**METROPOLITAN GOVERNMENT OF NASHVILLE AND DAVIDSON COUNTY**

**STAFF RECOMMENDATION**  
**1404 Lillian Street**  
**July 20, 2016**

**Application:** Demolition, New construction-infill  
**District:** Lockeland Springs-East End Neighborhood Conservation Zoning Overlay  
**Council District:** 06  
**Map and Parcel Number:** 08313032300  
**Applicant:** Kate Sullivan, Owner  
**Project Lead:** Sean Alexander, sean.alexander@nashville.gov

**Description of Project:** The applicant proposes to demolish a non-contributing house and construct a new one and one-half story house on the lot.

Figure 1: Principle dwelling at 1404 Lillian Street.

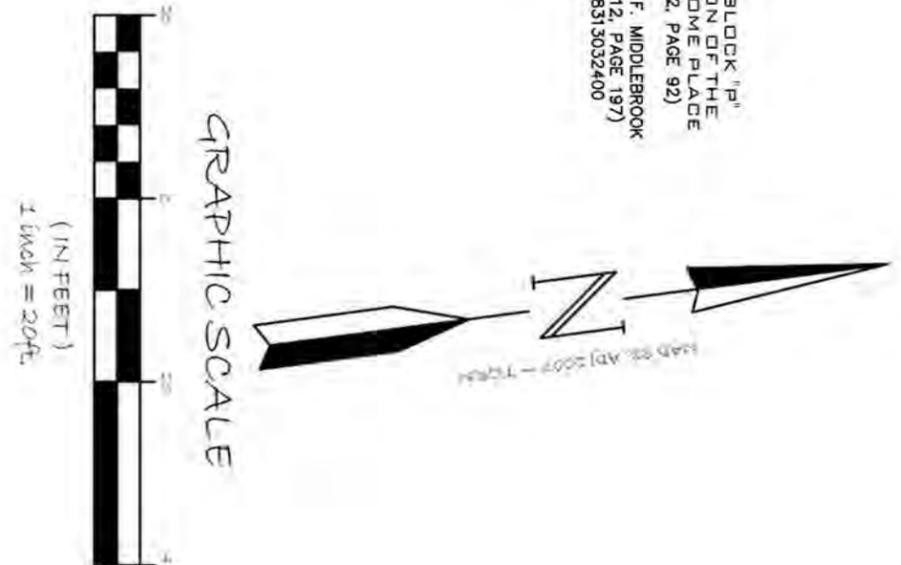
**Background:** The building at 1404 Lillian Street is a one story side-gabled house. Although the form is similar to that of a Craftsman style house, the house was constructed circa 1950, after the significant period of development for the Lockeland-Springs neighborhood. Therefore the house is not considered to be a contributing structure.

**Demolition:** Although 1404 Lillian Street resembles several nearby historic structures in its general form and appearance, Sanborn Fire Insurance maps show that it was constructed between 1945 and 1951. Also, the foundation is concrete block and the siding and windows are vinyl, which are not historic materials. Because of its later date of construction, demolition meets Section III.B.2.b for appropriate demolition and does not meet section III.B.1.b for inappropriate demolition.

FIRST FLOOR PLAN

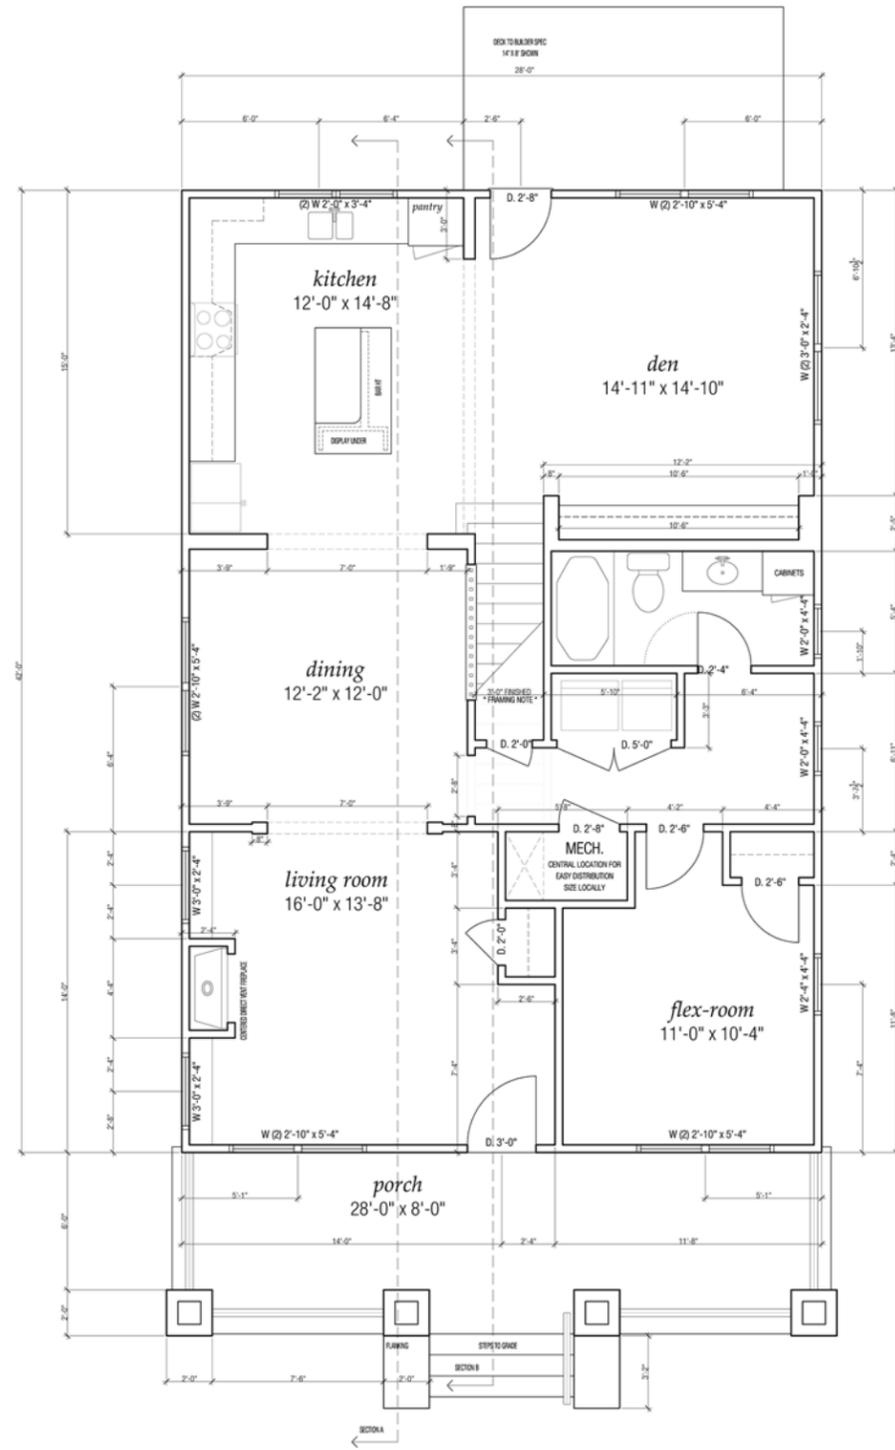
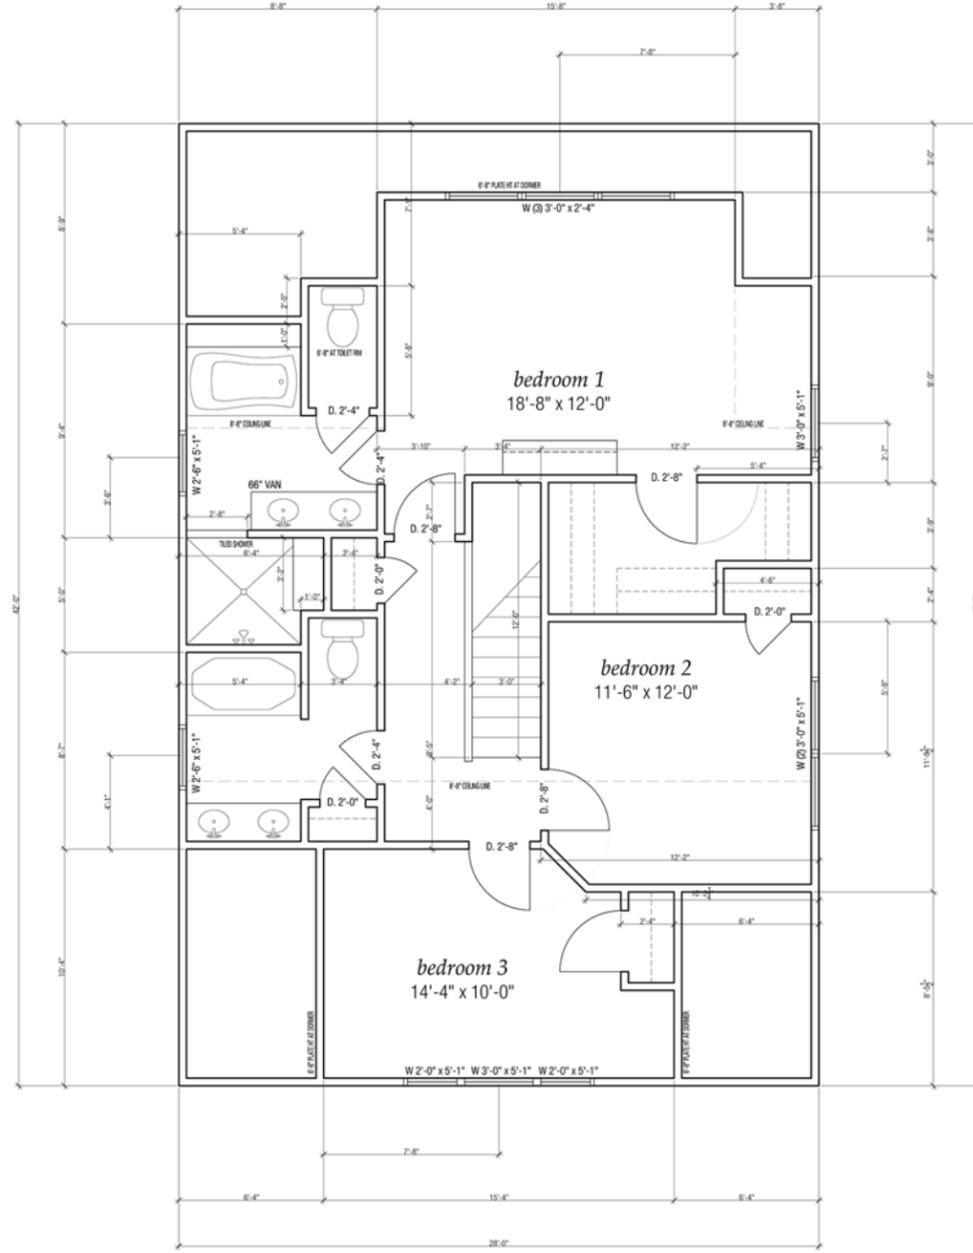
Proportion and Rhythm of Openings: The windows on the proposed infill are all generally twice as tall as they are wide on the left side of the house, as is typical of windows on historic buildings. On the right side, however, the majority of windows are shorter and narrower than those in the upperstory. On the right side of the house there will be no large expanses of wall space without a window or door opening, but on the left side toward the back there will be approximately eighteen feet (18') of wall without any door opening. Double and triple windows will have a four to six inch (4"-6") mullion between them. Staff recommends that the rhythm and proportion of windows be more typical of historic buildings with no expanse of wall space without any openings and that the first story windows are generally as large or larger than those of the upperstory.

1. The height of the porch floor shall be consistent with adjacent houses, to be verified during construction;
2. The front setback for infill at 1404 Lillian Street shall be the average of the adjacent buildings to be verified during construction;
3. The siding exposure shall not exceed five inches (5”) and that the roof color and selections of the windows and doors shall be administratively approved;
4. The front dormer shall be set back two feet (2’) from the wall below;
5. The driveway not be shorted;
6. The rhythm and proportion of windows shall be typical of historic buildings with no large expanses of wallspace without any openings and with the first story windows generally as larger or larger than those of the upperstory.
